Remarks

Reconsideration of the present application, as amended, is respectfully requested. Response will be made with reference to the Examiner's comments and by the paragraph number in which such comments were made.

Fig. 4

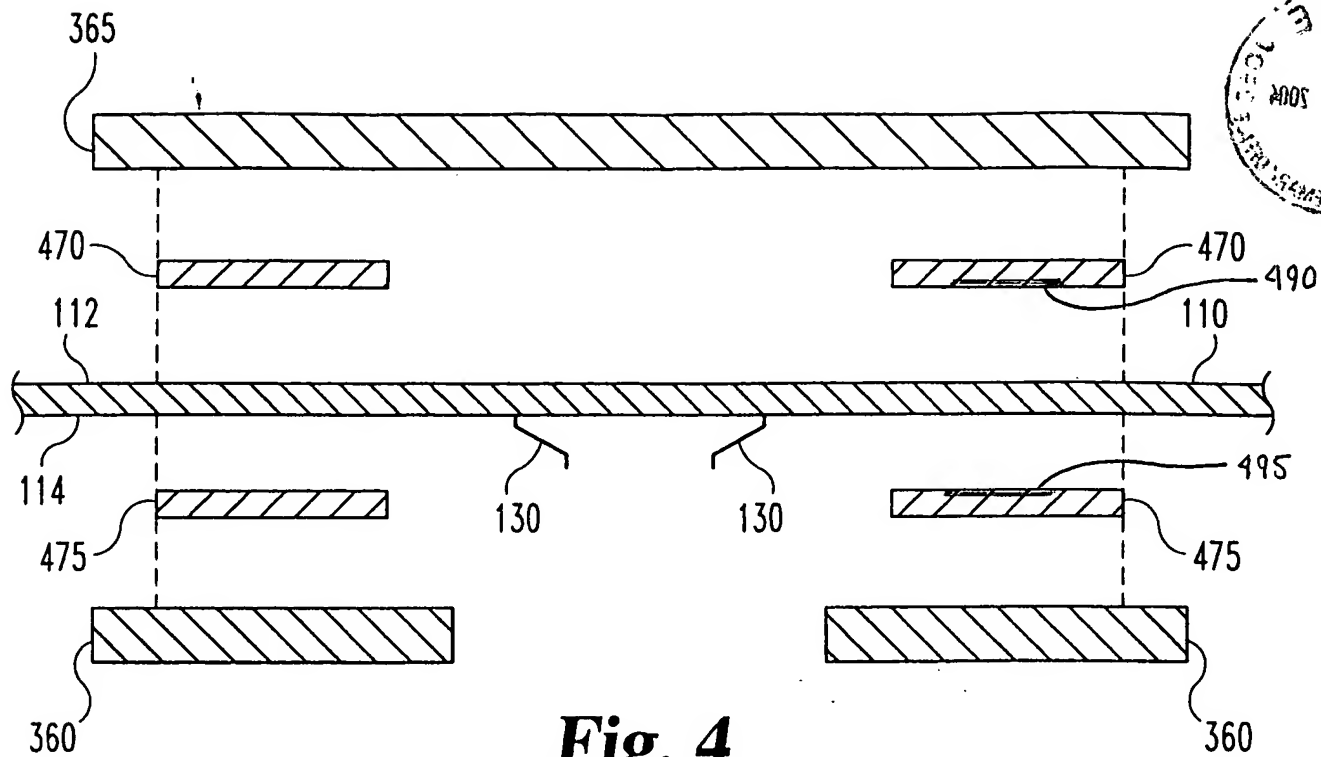
4-5. The Examiner stated that it is unclear what "a temperature sensor" represents. Persons skilled in the art would understand "a temperature sensor" to be any sensor that detects or senses the temperature and relays a signal indicating such temperature. Such devices have long been known by persons skilled and unskilled in the art. Common examples, which are not intended to be exclusive, include mercury thermometers (with an optical output), thermocouples (varying voltage output) and thermistors (varying resistance output). A proposed amendment to Fig. 4 is enclosed, the amendment being to include temperature sensing elements 490, 495 incorporated in control elements 470, 475, as described at page 11, lines 15-16 in the specification. Approval of the amendment to Fig. 4 is respectfully requested. The specification at page 11, lines 15-16 has been amended to

include reference numbers 490/495. Claim 4 is believed to be allowable under 35 U.S.C. 112.
